**GENOA CHARTER TOWNSHIP
PLANNING COMMISSION
PUBLIC HEARING
September 9, 2013
6:30 P.M.
AGENDA**

OPEN PUBLIC HEARING #1... Review of site plan, special use, and environmental impact assessment for proposed 16,120 square-foot gymnasium and classroom addition for Brighton Nazarene Church, located at 7669 Brighton Road in Section 25, petitioned by Brighton Nazarene Church.

Re: Brighton Nazarene Church Facility Expansion
Site Plan Review
Boss File No. 13-100

Attention:	Kelly Van Marter, AICP Assistant Township Manager and Planning Director
Subject:	Brighton Nazarene – Special Land Use and Site Plan Review #3
Location:	7669 Brighton Road – northwest corner of Brighton and Aljoann Roads
Zoning:	SR Suburban Residential District

SITE PLAN

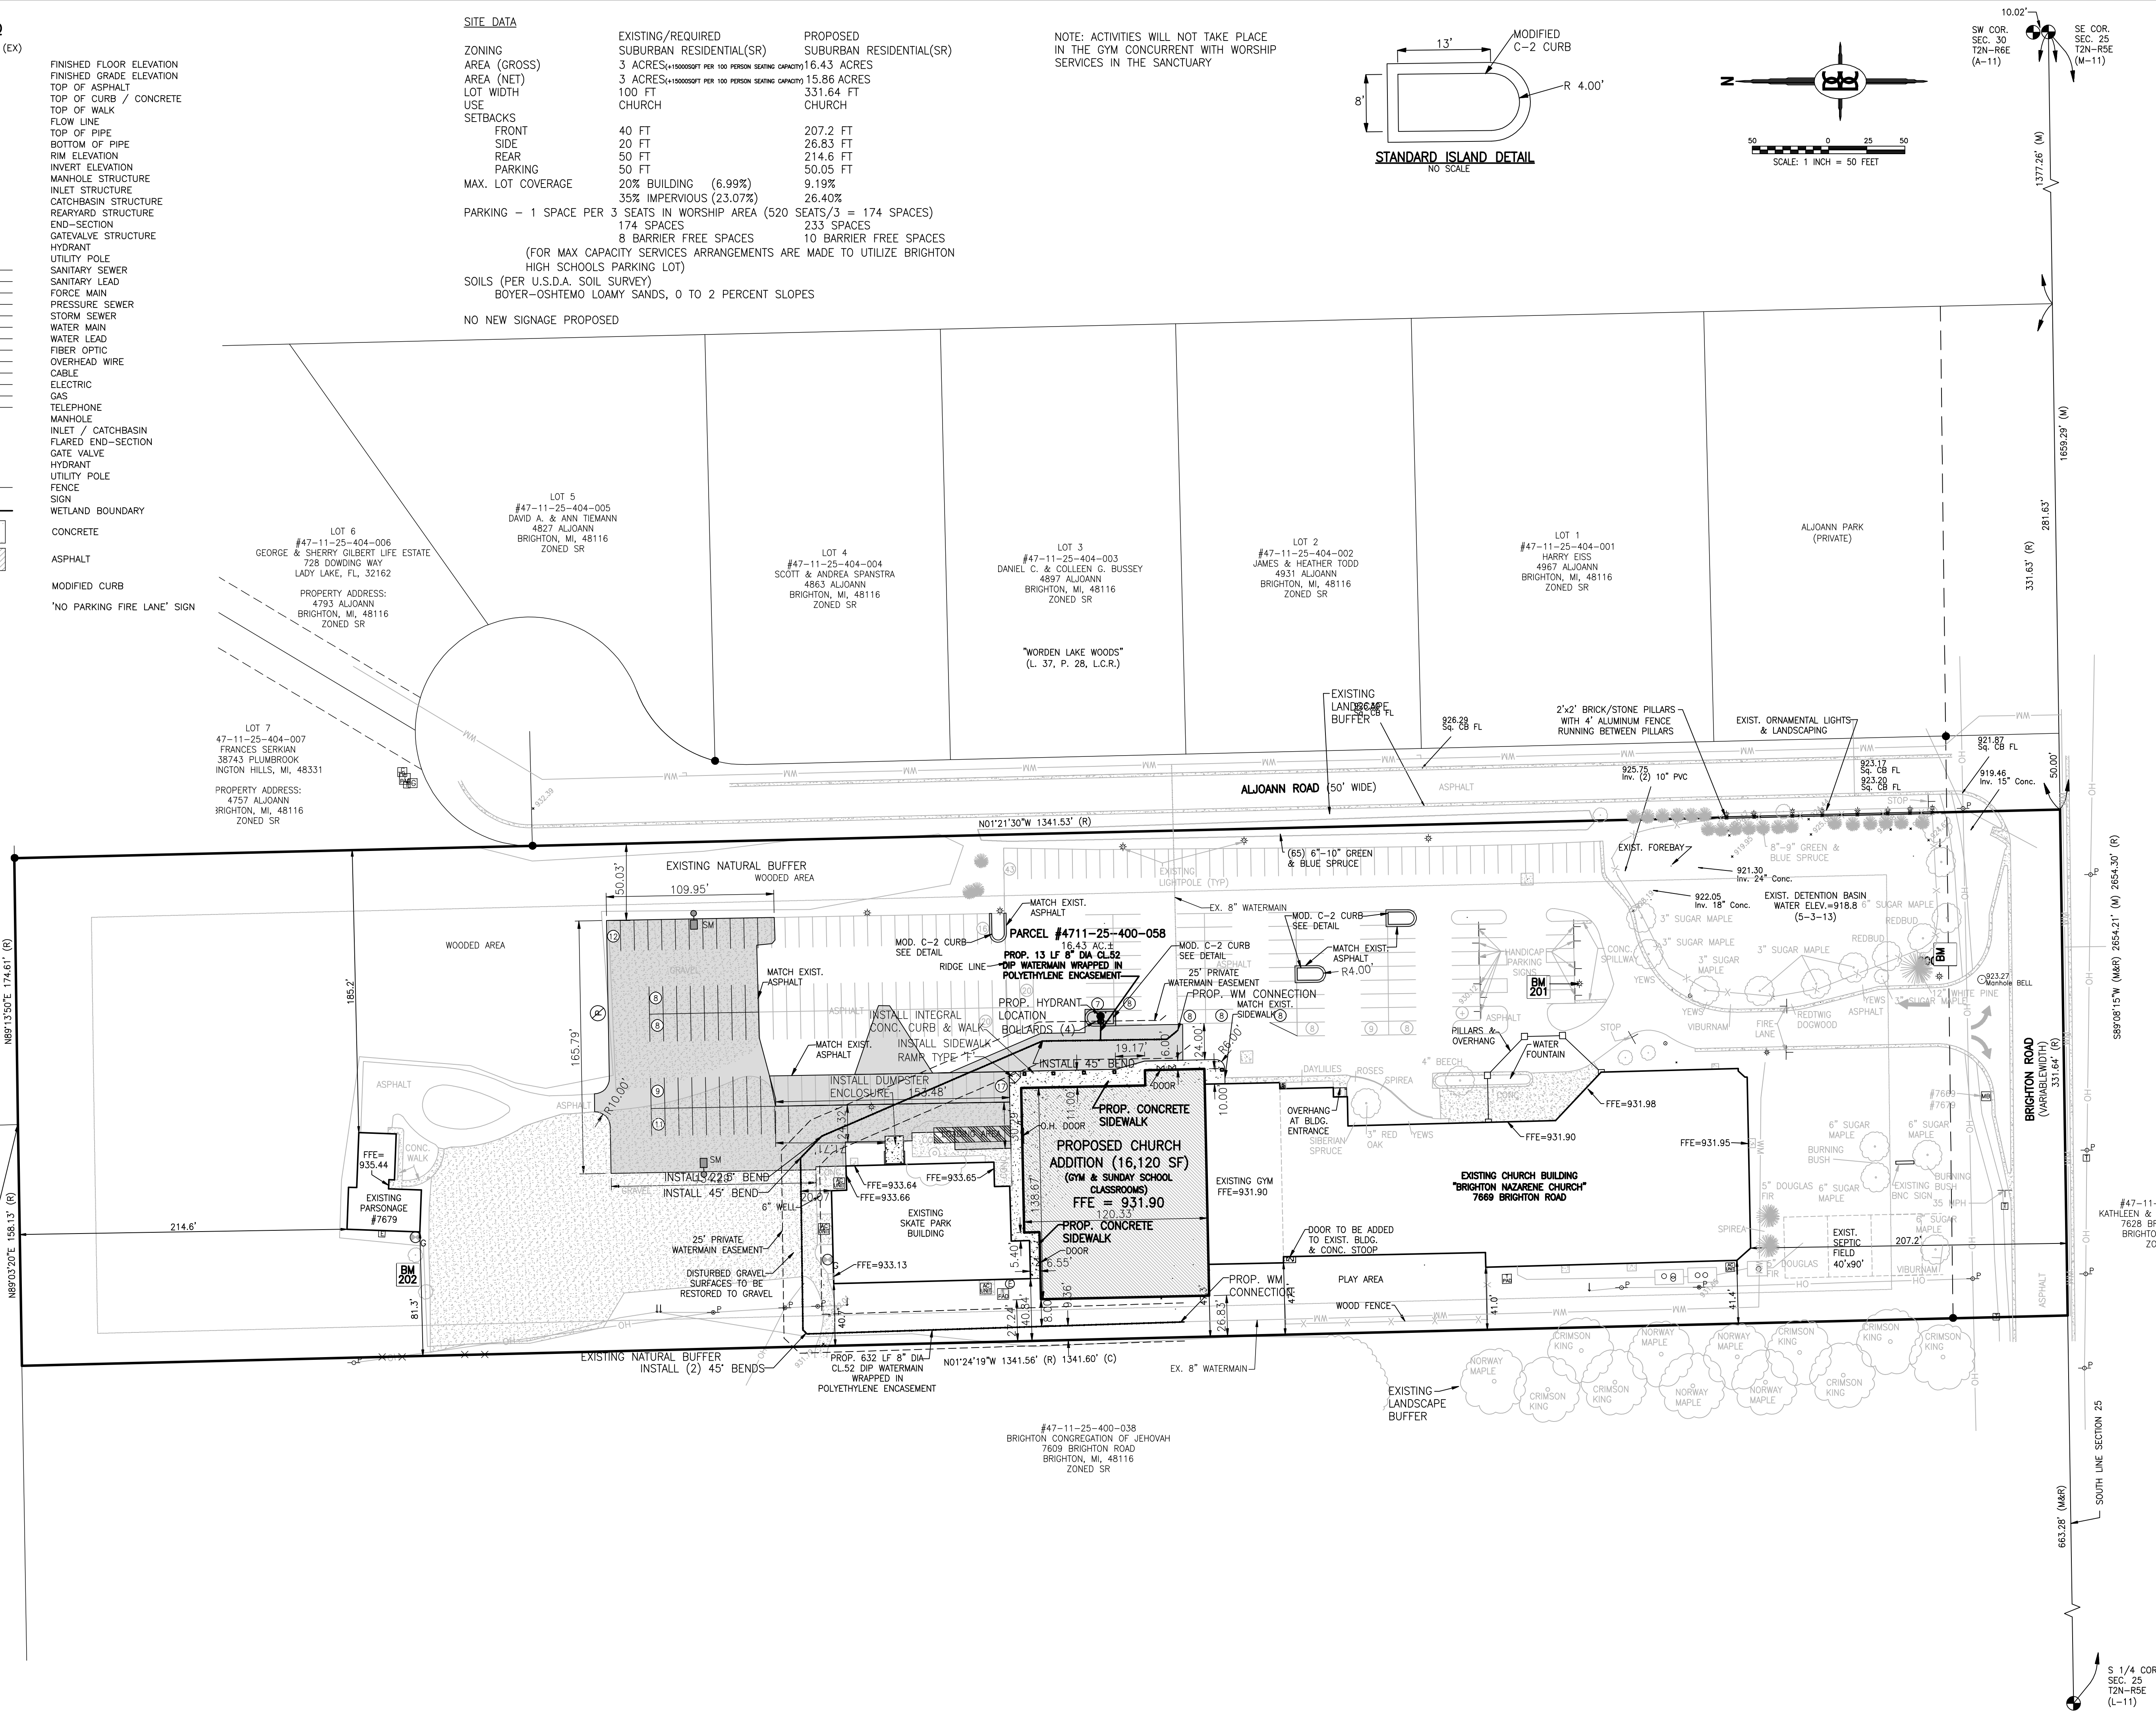
The calculations on Sheet 3 identify an existing capacity of 520 seats in the worship area. This calculation requires a minimum lot area of roughly 5 acres, while the site contains 15.8 acres (net). This condition is met.

- 3. Parking and Vehicular Circulation.** In accordance with Section 14.04, churches and similar places of worship require 1 parking space for each 3 seats in the main unit of worship. Based upon the calculations provided by the project engineer, 174 spaces are required, while 233 are provided. The amount of parking proposed requires Planning Commission approval as it constitutes 134% of the minimum requirement (120% is the maximum allowed without such approval).

- 5. Loading.** Given the overall size of the buildings in combination, Section 14.08.08 requires upwards of 3 loading spaces, which are to be located in a rear or side yard not directly visible to a public street. The revised site plan includes a new loading area behind the proposed building addition.

The revised plan includes 6 new canopy trees located in parking islands, as well as 34 new evergreen trees along the east and west side lot lines and 34 new shrubs to screen the play area and mechanical equipment in the west side yard.

As was discussed at the August 12th meeting, the applicant also proposes 3 new parking lot islands to break up the large expanses of pavement. Lastly, a note has been added stating that all existing trees that are dead will be replaced.

1. Landscape and lighting notes were clarified as "Existing" on sheet 2.
2. A "No New Signage Proposed" note was added to the site data on sheet 3.
3. A 500 Sq. Ft. Loading area was designated on sheet 3.
